A D D E N D U M

Project No.: 2501101
Project: EACS Restroom Renovations

Addendum No: 02
Date: 04/02/2025

ADDENDUM NO. 02, to Drawings and Specifications dated 03/12/2025, for the EACS Restroom Renovations for the East Allen County Schools; as prepared by ELEVATUS Architecture, 111 E. Wayne Street, Suite 555, Fort Wayne, IN 46802

FIRST FLOOR RESTROOM MECHANICAL PLAN

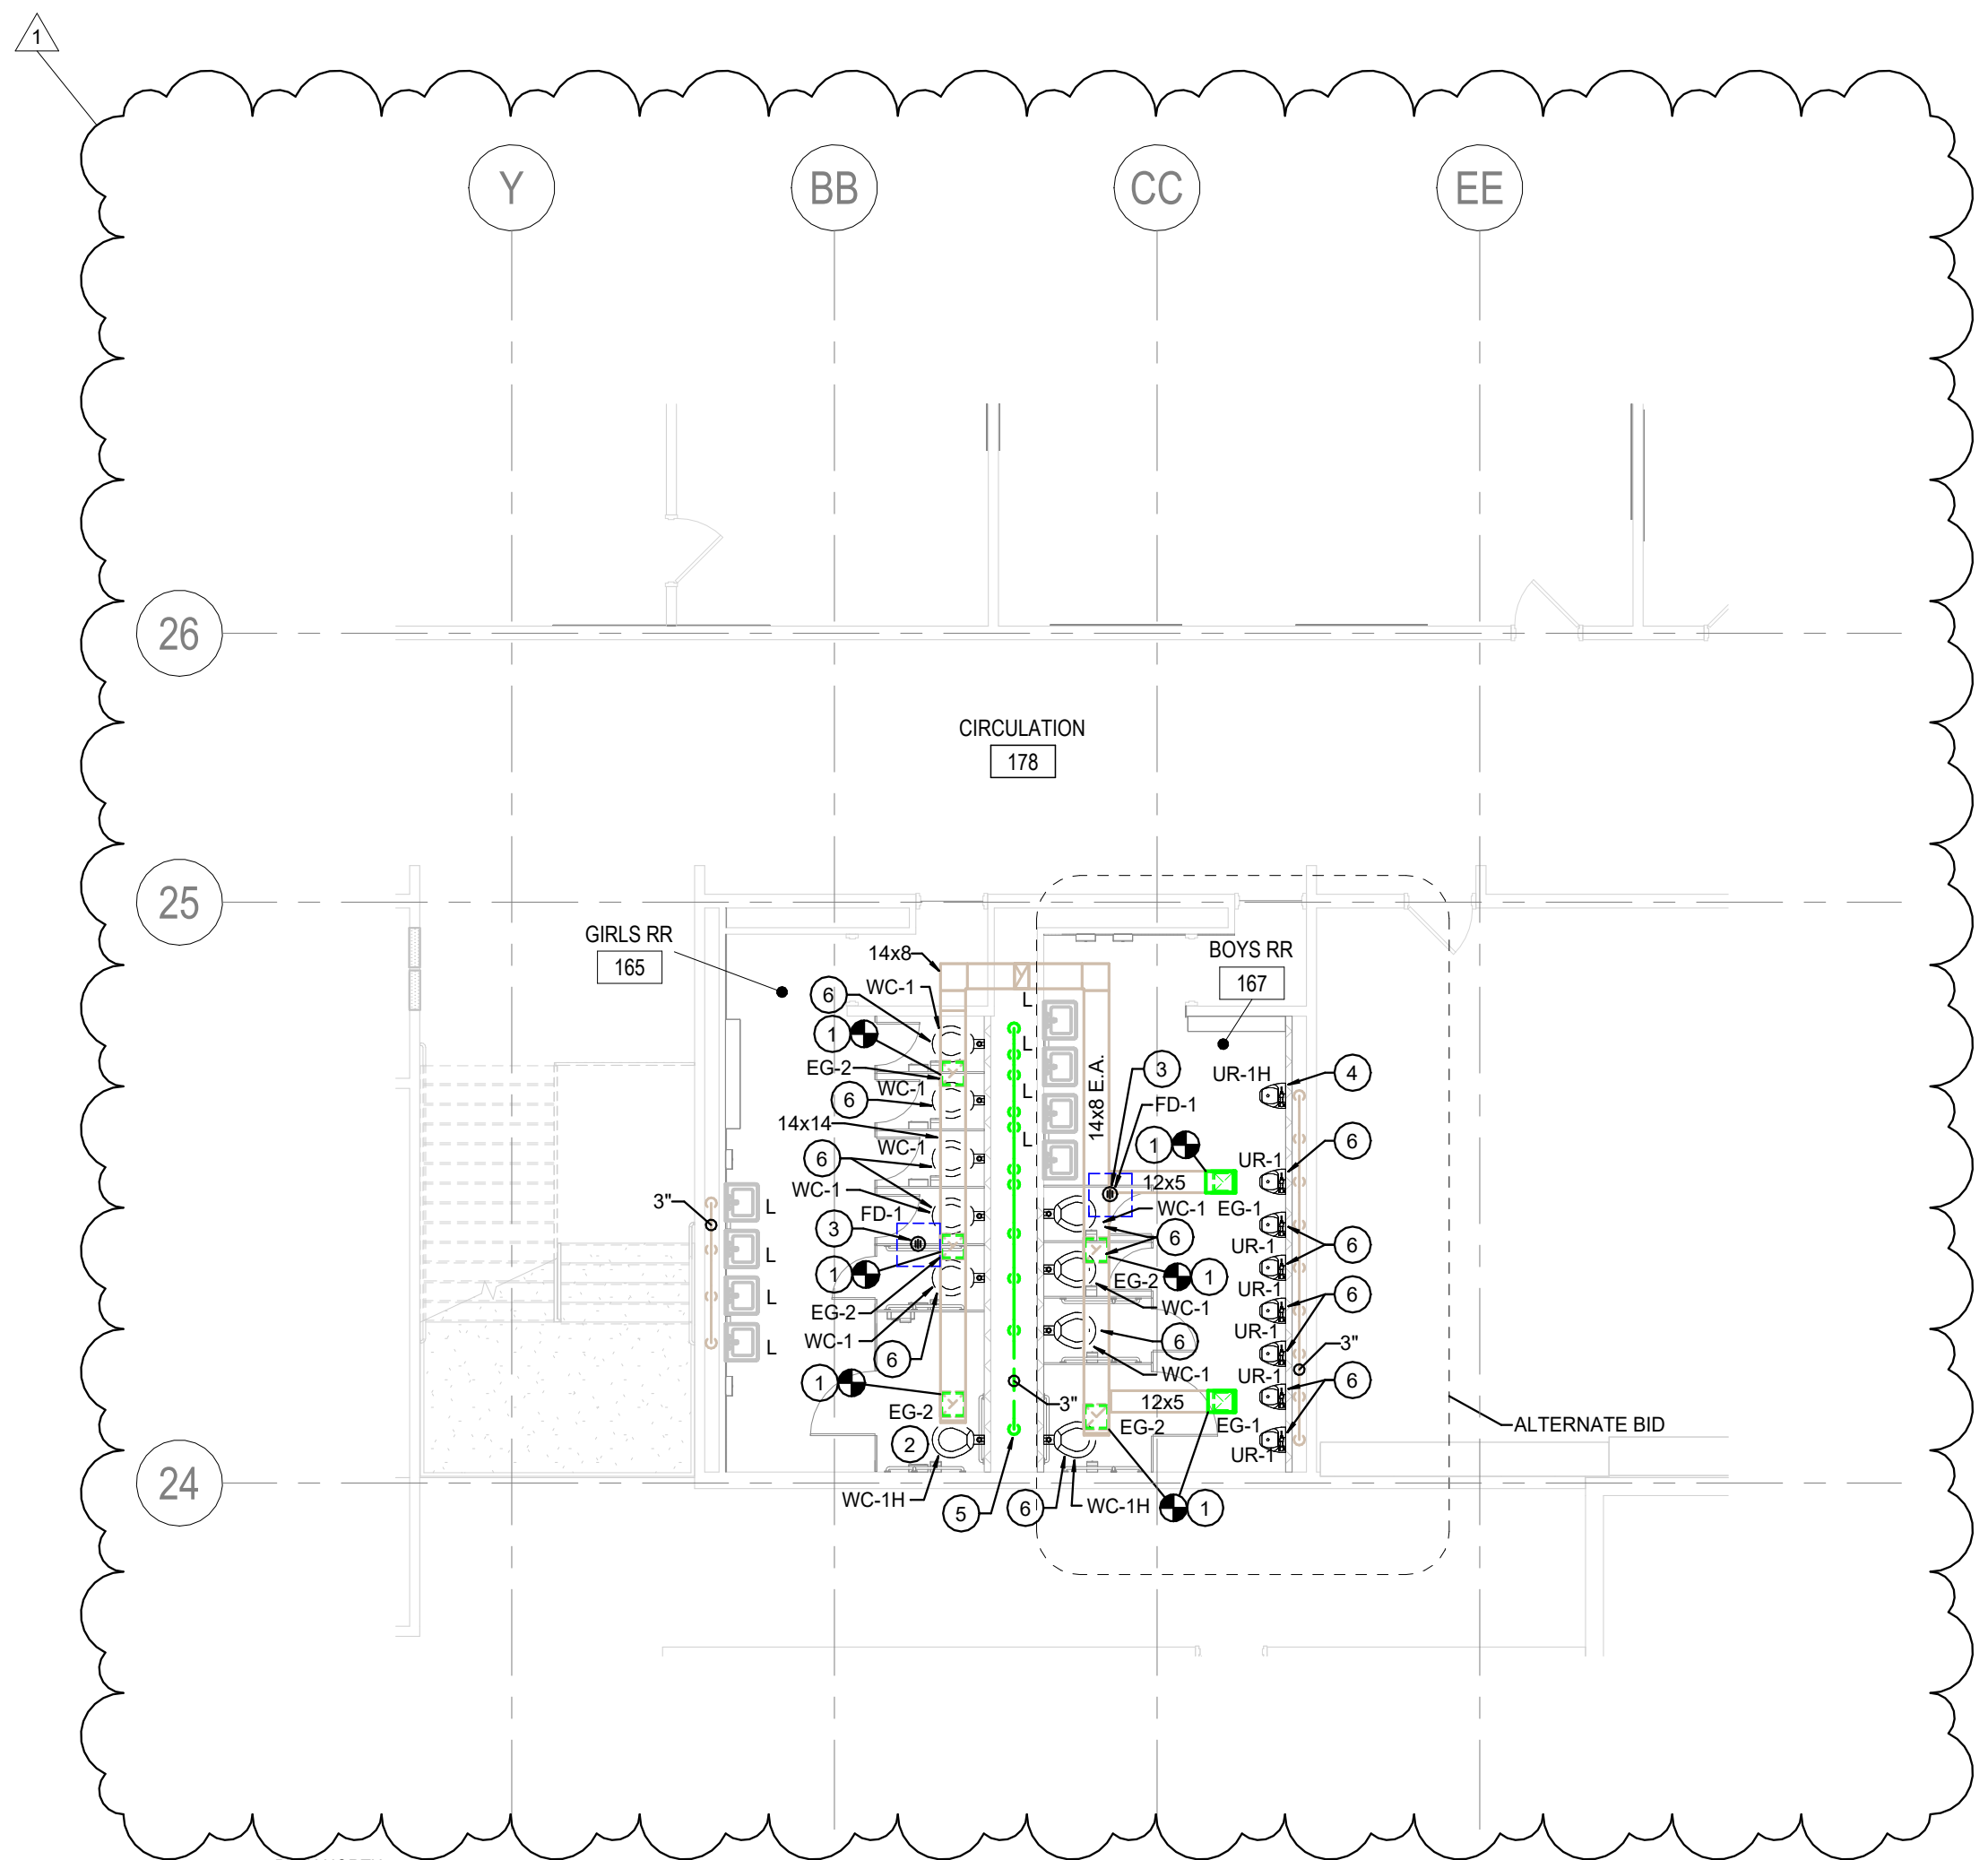
Item #3: Heritage HS: Drawing Sheet M201, "First Floor Restroom Mechanical Plan"

- A. Revise plumbing and mechanical layout to accommodate for shift in toilet partitions. Refer to drawing sheet M201 labeled Addendum #3 for more information.**
